The applicant is requesting approval of Eli Estates, a 1.65 acre subdivision for 10 lots, located at 1550 S. Ivy Street, on the east side of S. Ivy Street, just north of SE 16th Avenue, and zoned R-1.5 Medium Density Residential. (SUB 14-03)

SUBDIVISION STAFF REPORT
FILE #: SUB 14-03, ELI ESTATES
Prepared for the June 23, 2014 Planning Commission Meeting

Fence and Wall Plan

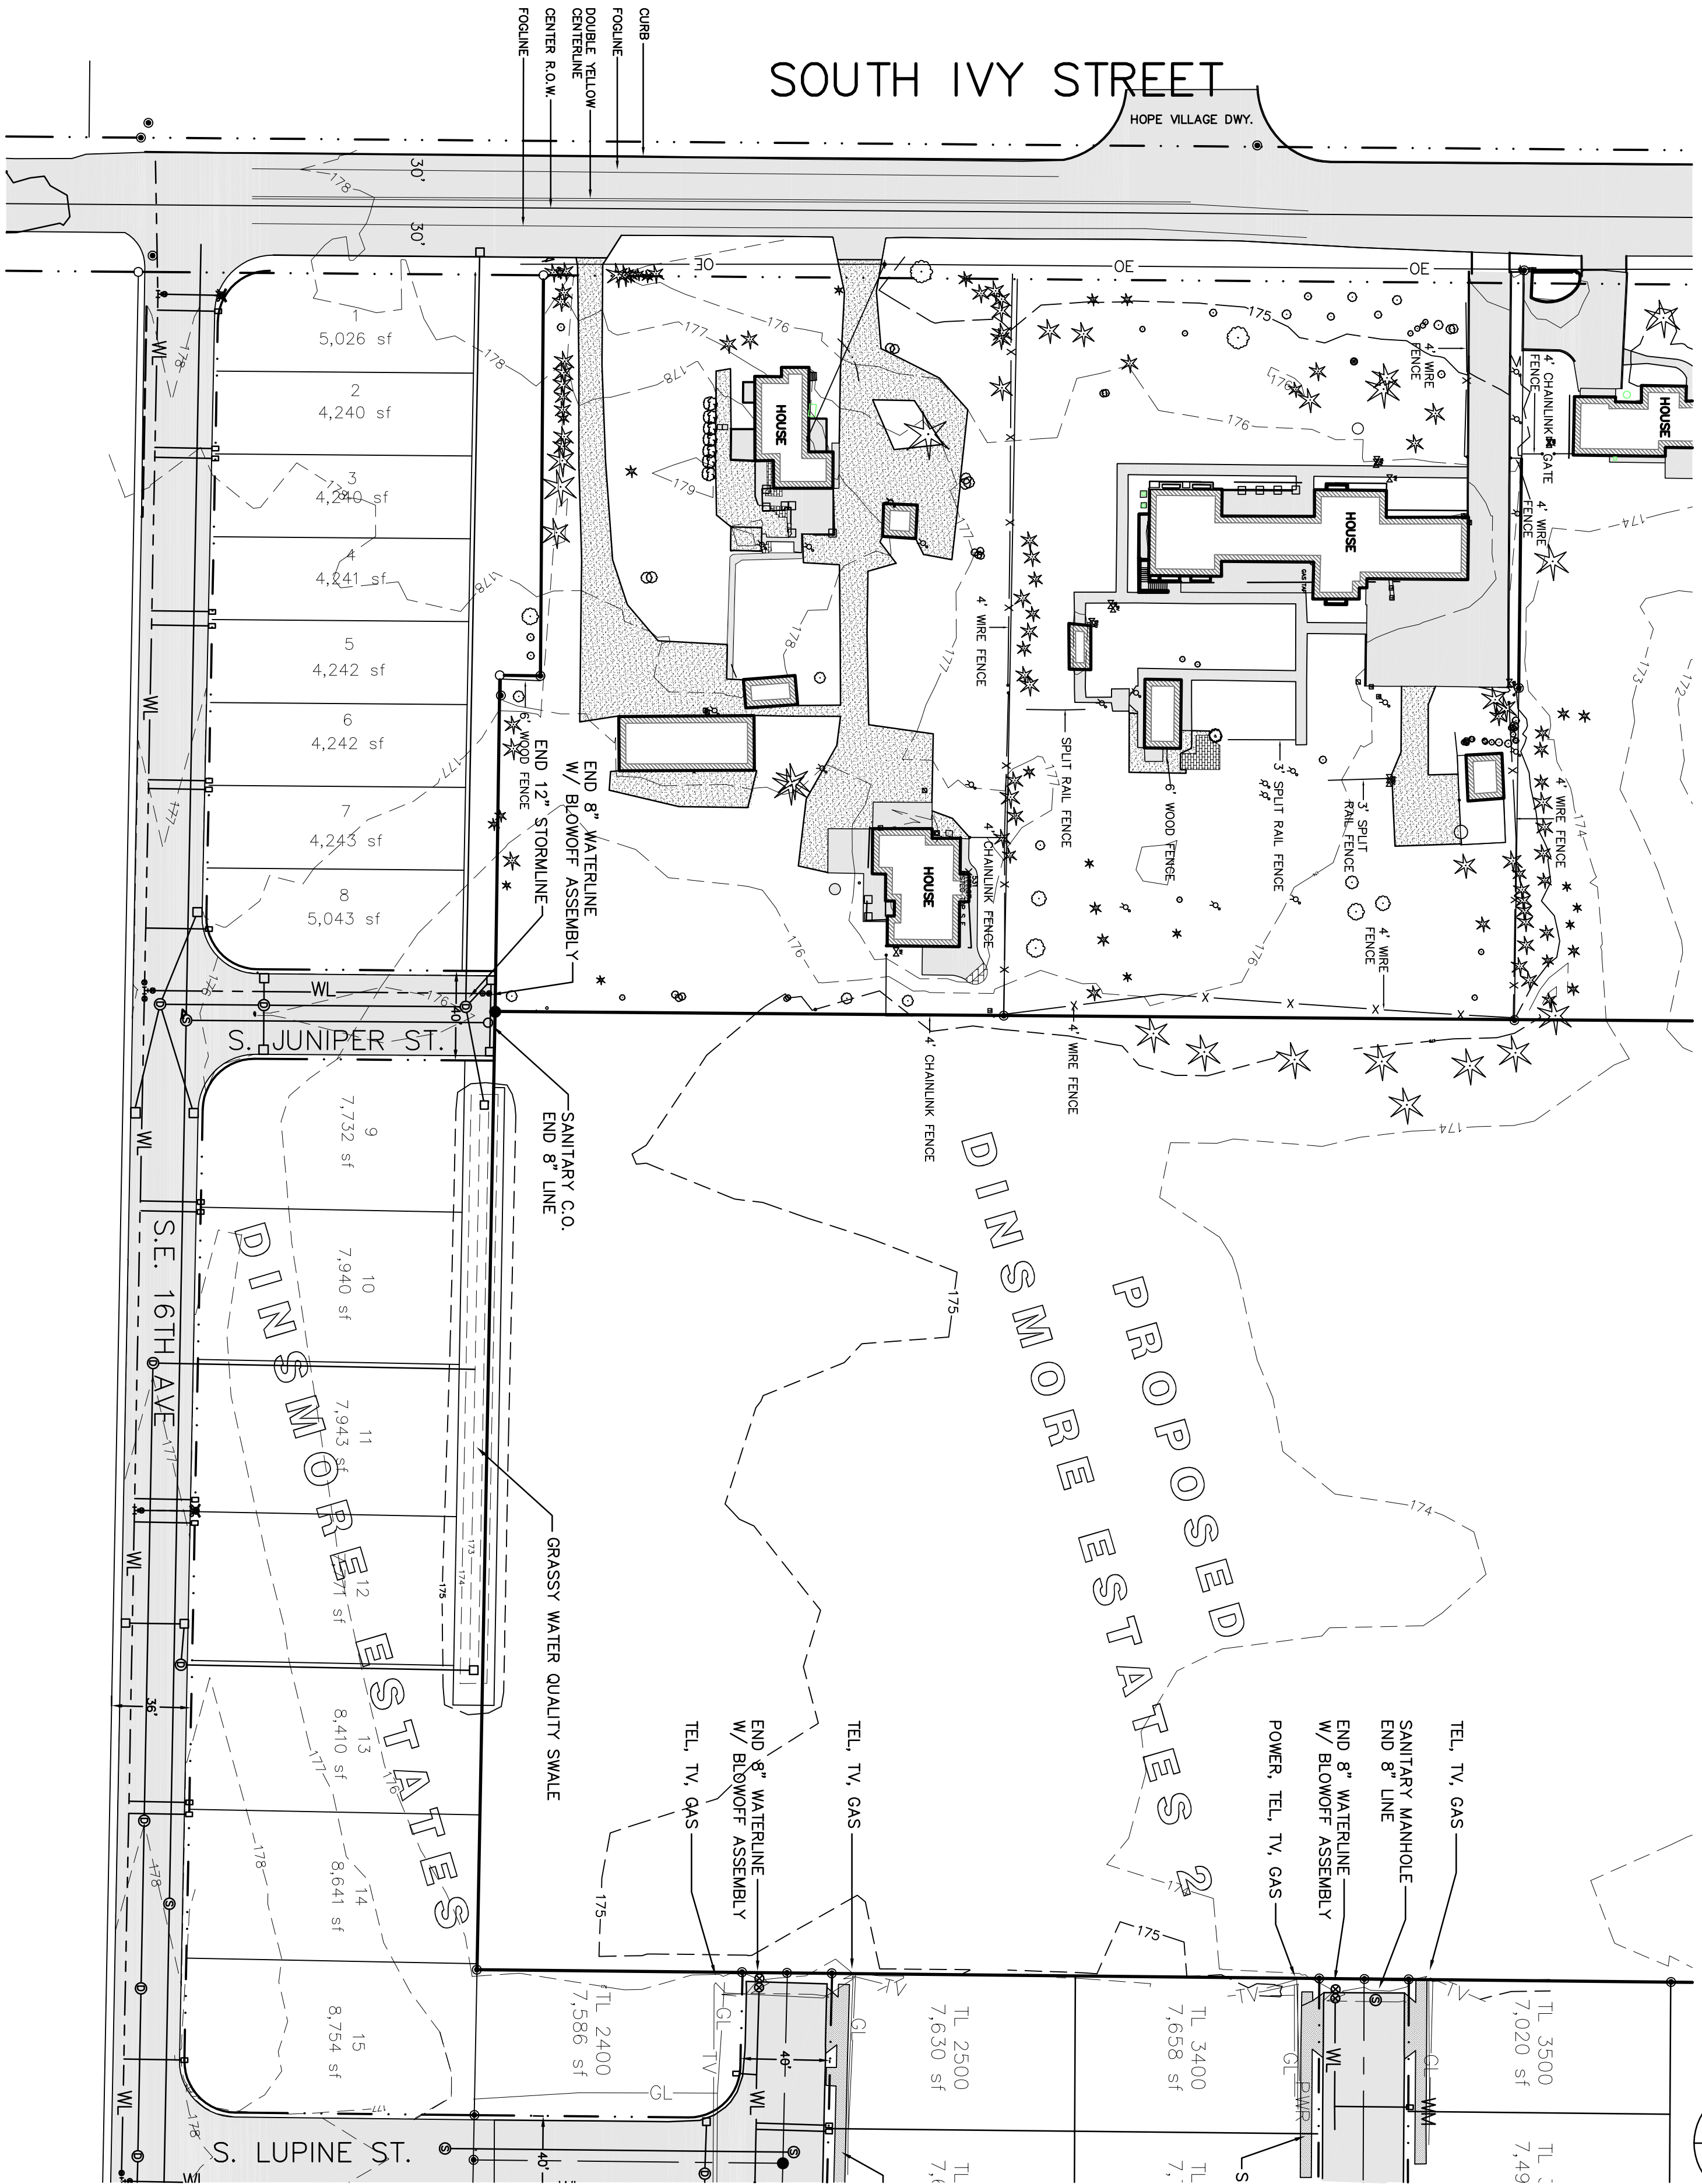
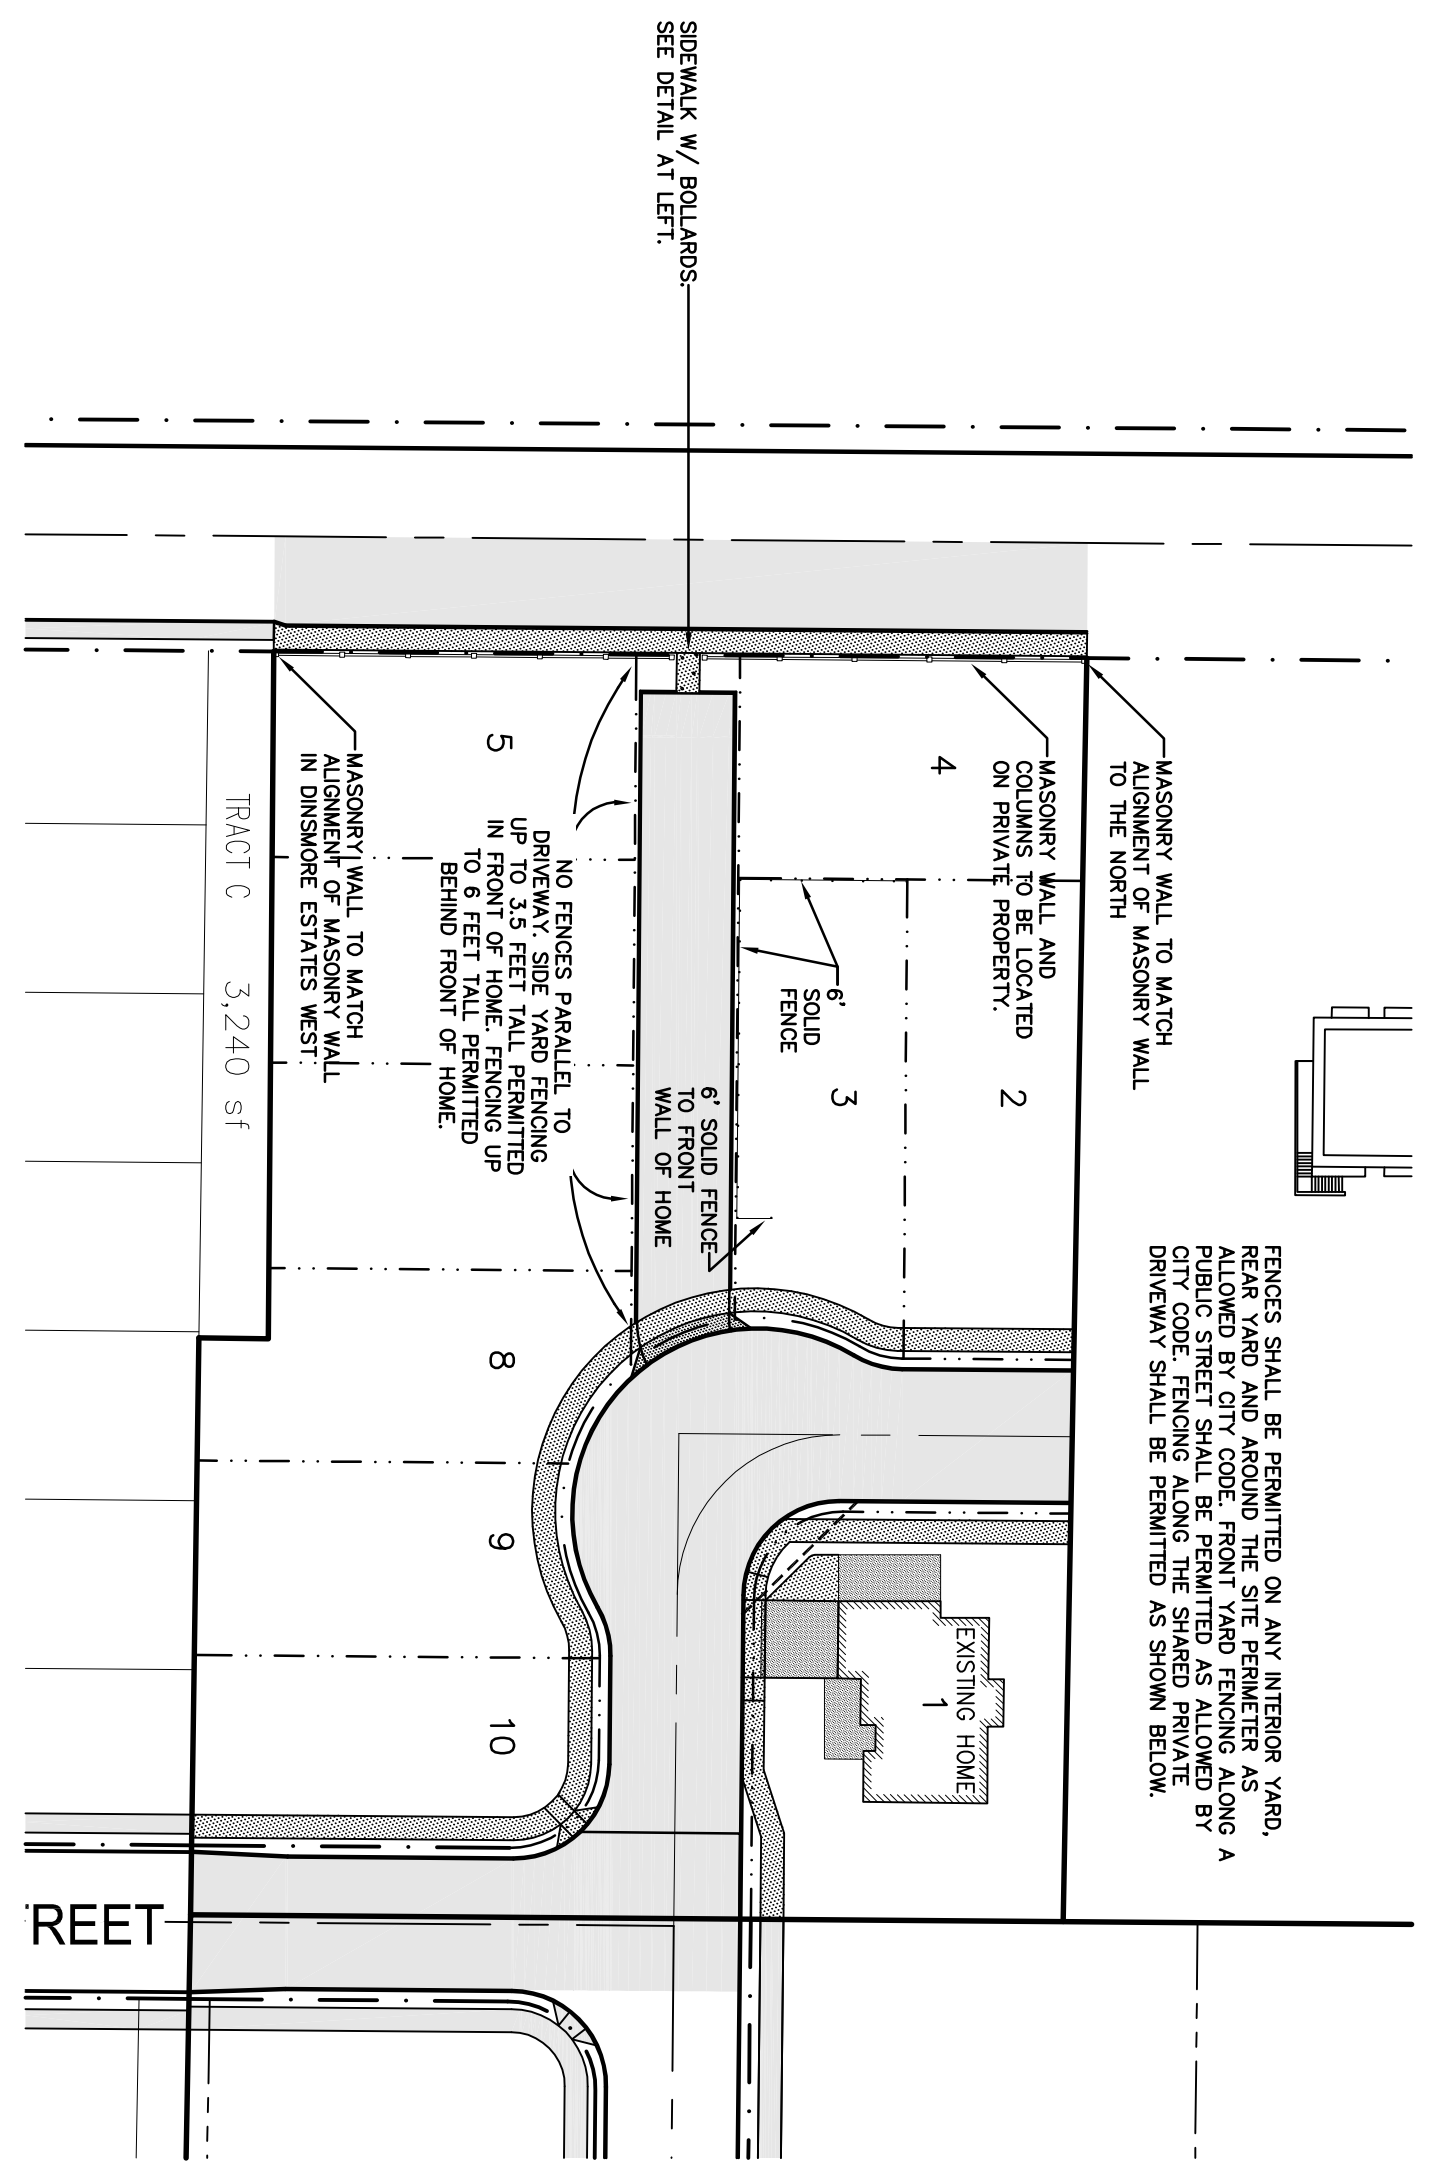
Other fences throughout the interior of the site may be proposed, but these interior fences will meet all of the city's requirements. See Sheet 4, Fence and Wall Plan.

Finding: The proposed solid masonry wall on Lots 4 and 5 along the right of way of S Ivy Street is designed to reduce vision impacts and noise impacts of higher speed traffic along S Ivy Street. This issue is discussed in 16.08.110 on page 5 and merits further discussion by the applicant and review by the Planning Commission.

43. The solid masonry wall along the frontage of S Ivy Street of Lots 4 and 5 shall be constructed as shown on Sheet 4 Fence and Wall Plan, or as modified by the Planning Commission. Because there will be no HOA for Eli Estates, deed restrictions shall be filed for Lots 4 and 5 to insure maintenance.
44. Any other fences and/or walls constructed on lots with the Eli Estates subdivision shall meet all City requirements and regulations.
